## Department of Transportation

#### MEMORANDUM

**SUBJECT:** ZC Case No. 22-06 – 899 Maine Avenue SW

Figure 1 | Site Plan

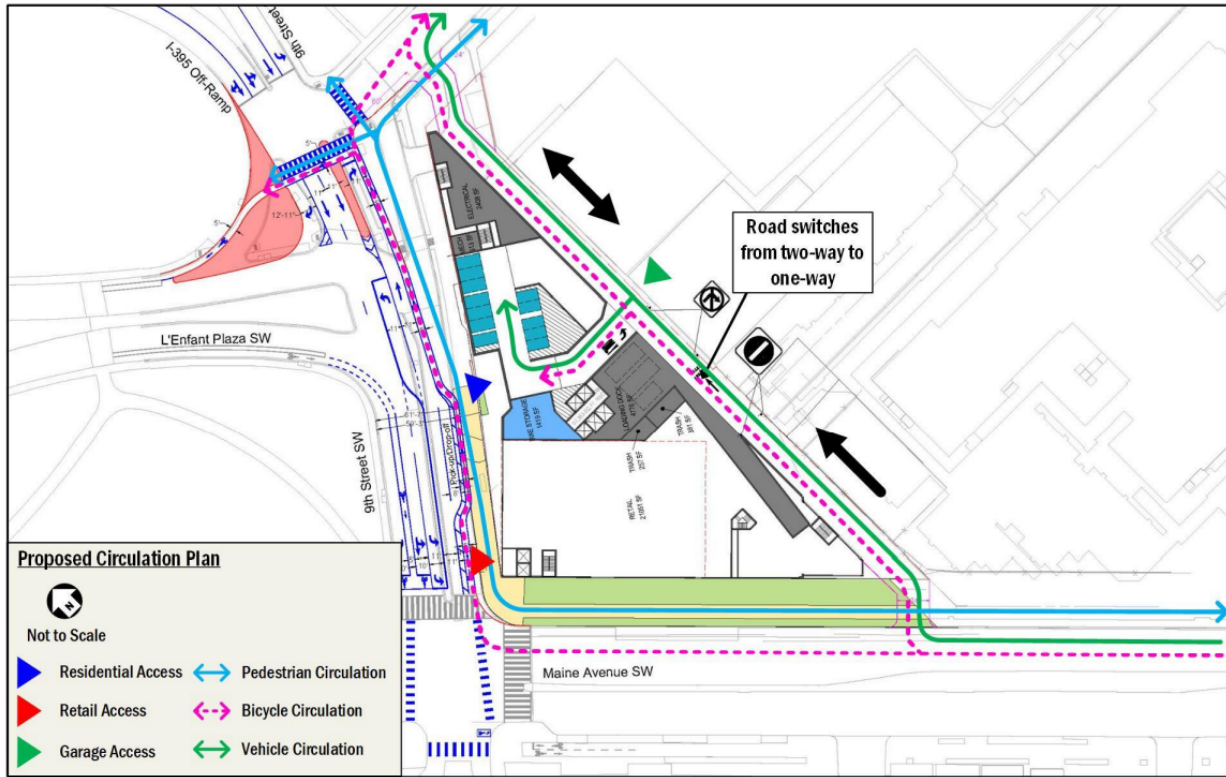
While the preliminary public space plans, shown above in Figure 1, are generally consistent with DDOT standards, there are several considerations that need to be reviewed in greater detail during the public space permitting process:

- Install appropriate signage (TBD) along the private alley and a chain, or similar device, across the driveway that will only be temporarily removed by the Loading Manager when a truck larger than 35 feet in lengths arrives at the site;

- The curb cuts on both G Street SW and Maine Avenue SW, including signage and markings to indicate the shift from one-way to two-way in the alley;
- The position of curb cut on G Street may need to shift to the west to ensure the private alley is does not have a jog through public space;

- Continue to refine the design of the bicycle lanes, slip lane closure, and streetscape changes on 9<sup>th</sup> Street SW in coordination with DDOT's Planning and Sustainability Division;

- Submit a detailed curbside plan showing the proposed signage and restrictions along both fronting streets;
- Provide a plan showing the detailed design of the long-term bike storage room so PSD can confirm it meets the DCMR 11 (Chapter 800) and DCMR 18 (Chapter 1214) requirements and DDOT *Bike Parking Guide* best practices; and

- Determine final locations for the inverted-U bicycle racks.
